MEMORANDUM

REVIEW TYPE: Preliminary Plan of Subdivision for 73 one family attached unit
(including 10 MPDU's)

PROJECT NAME: Fairland View

CASE NO. 1-05001

Sitting Area "A" Layout
 Date: 11/11/00

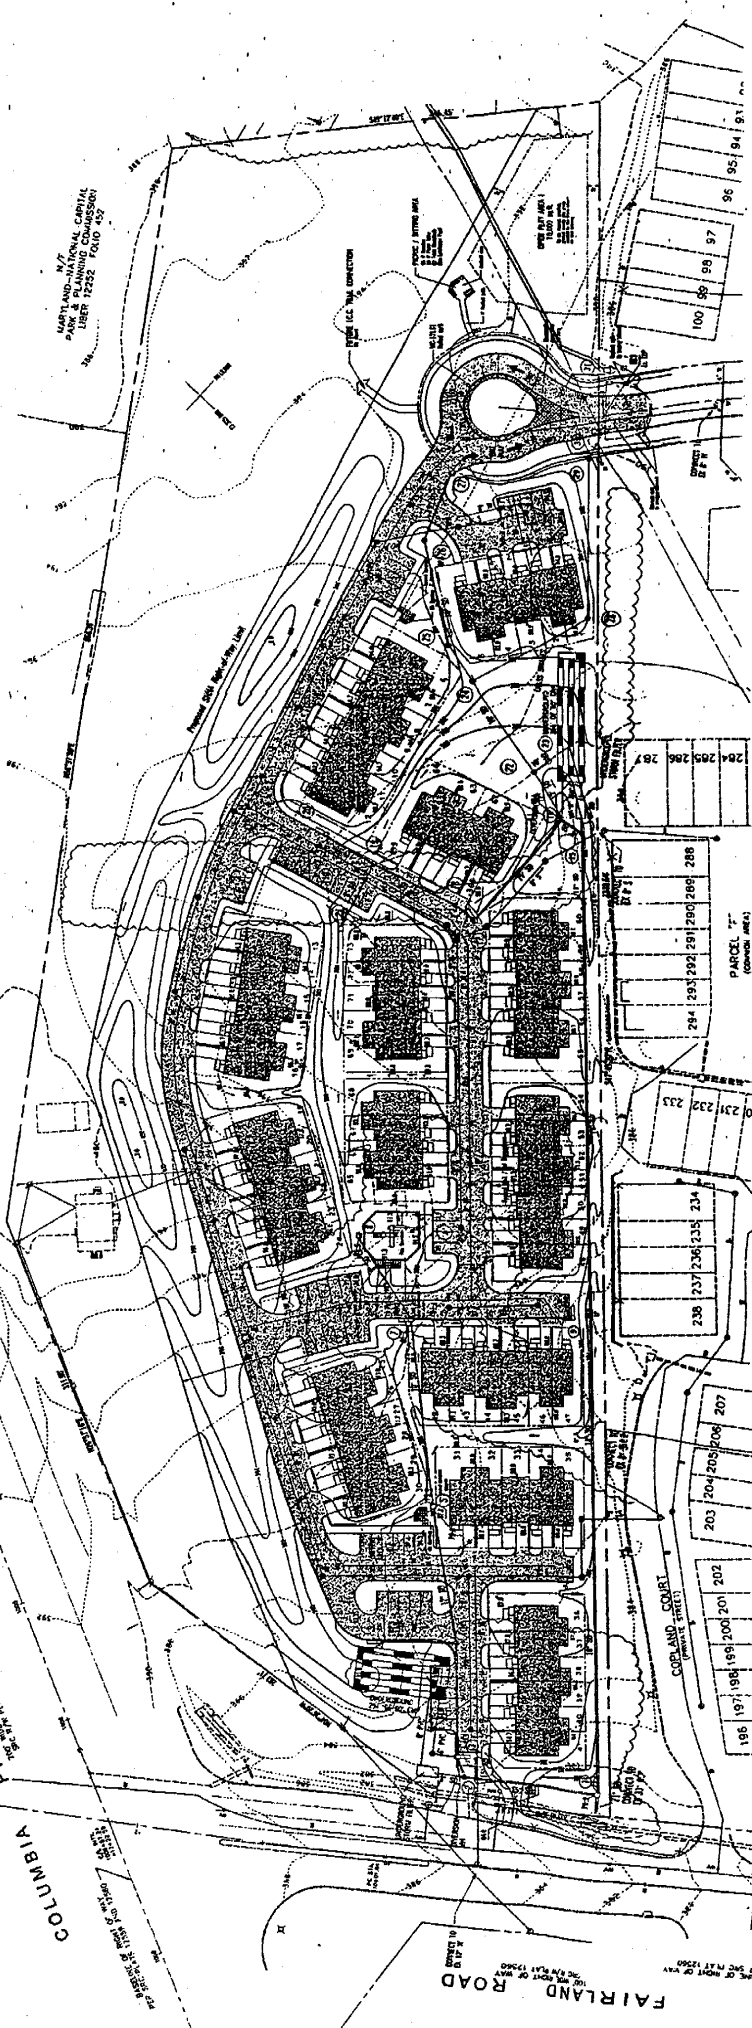
- 6) Limit any future development as part of this subject Preliminary Plan on the site to 73 townhouse units.
- 7) Dedicate, and show on final record plat, adequate right-of-way along Fairland Road to provide 50 feet of right-of-way from the roadway centerline.

- 8) Construct Stravinsky Drive extension and its terminus within the property as a 60-foot wide secondary residential street with sidewalks, and with proper termination (with a cul-de-sac).

The plan shows an open strip on the northern boundary that is to be used for screening and a potential berm to visually screen the units from any ICC improvements.

A final decision on the need to restrict the parking by MCDPWT has not been made, however, the applicant has provided MCDPWT with a requested study that indicates 18 spaces may be lost on Stravinsky if parking is restricted. The applicant has attempted to address this and respond to the Planning Board's concerns about visitor parking internal to the site by increasing parking by 20 visitor spaces.
